Title: Heater Upgrade II.1		
AG-SB-2023-05-B-ENR1	Effective Date: 01.12.2023	Compliance Category: A - MANDATORY B - RECOMMENDED C - OPTIONAL
Applicability		
Aircraft type & model: Cavalon	Affected Serial number(s): built after 05/2022 and before 10/2023	
The maintenance manual to be referenced is this stated or subsequent issue.		As per AutoGyro website
This form is the response from AutoGyro GmbH either against a problem found in the product in service requiring a containment or rectification action, or as service information for aircraft modification incorporation. For help, contact airworthiness@auto-gyro.com .

Reason and overview of the Service Bulletin (cause of problem if known)

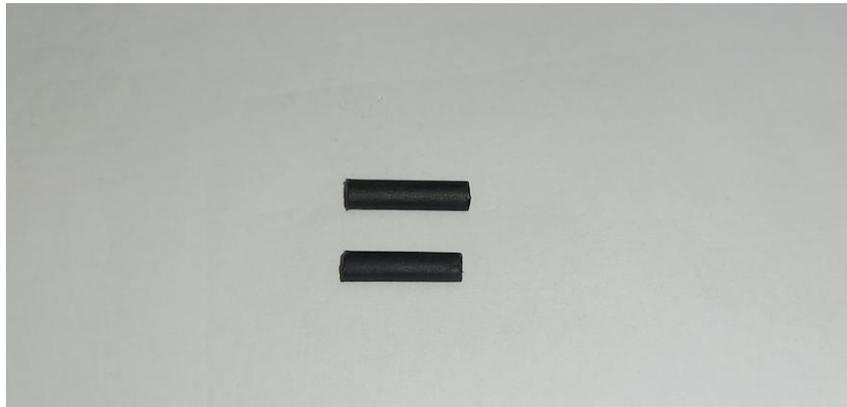
- 1.) Remove the cap of the rotary control by pulling it off.

2.) Loose the nut and remove the potentiometer to the backside of the panel.

3.) Cut two pieces of shrink sleeve to 10mm and put in on both sides of the electrical resistor.

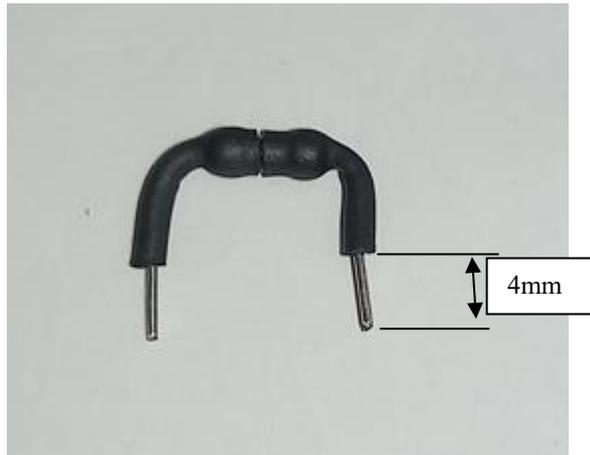
- 4.) Shrink the sleeve and cut both ends of the resistance to approximately 4mm.

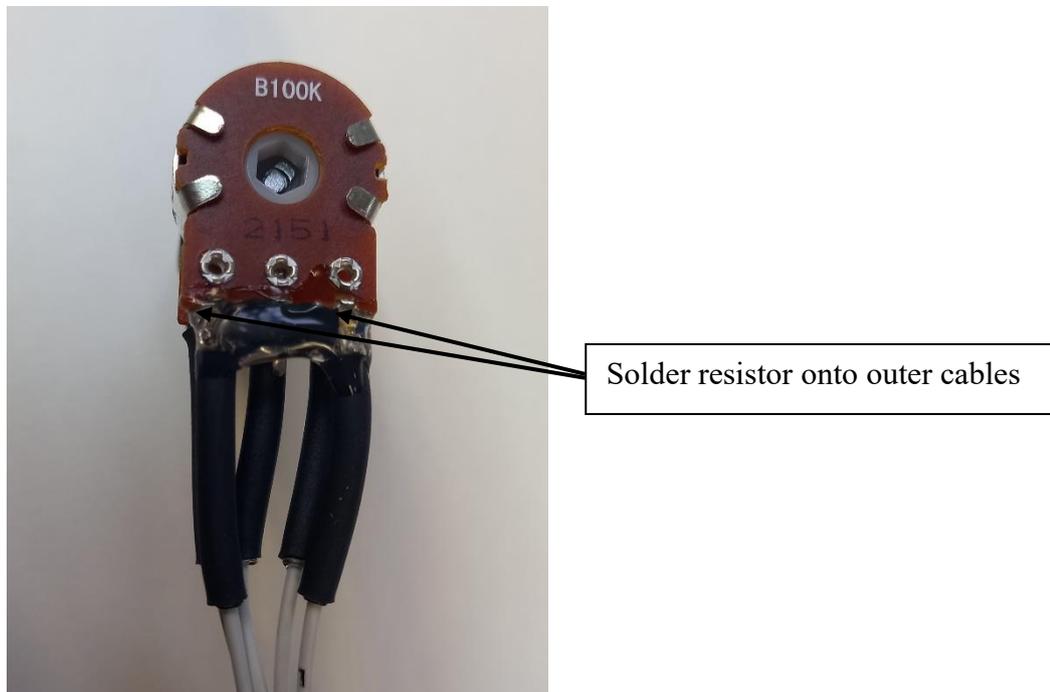
- 5.) Install the resistance onto the potentiometer (be careful to cover the potentiometer against Solder) – check afterwards for secure connection.

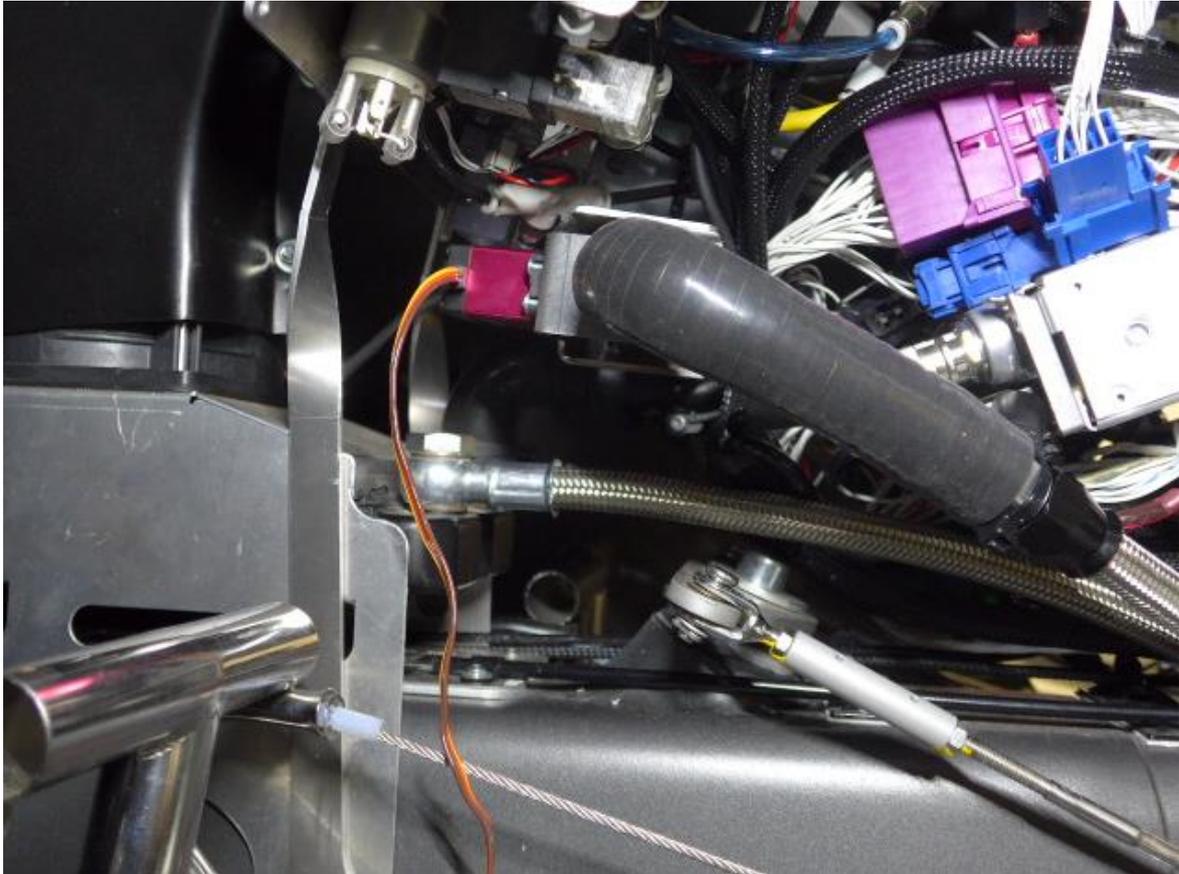
Clamp removed, hose removed from old valve unit, here to see on the left side, same on the other side with the clamp
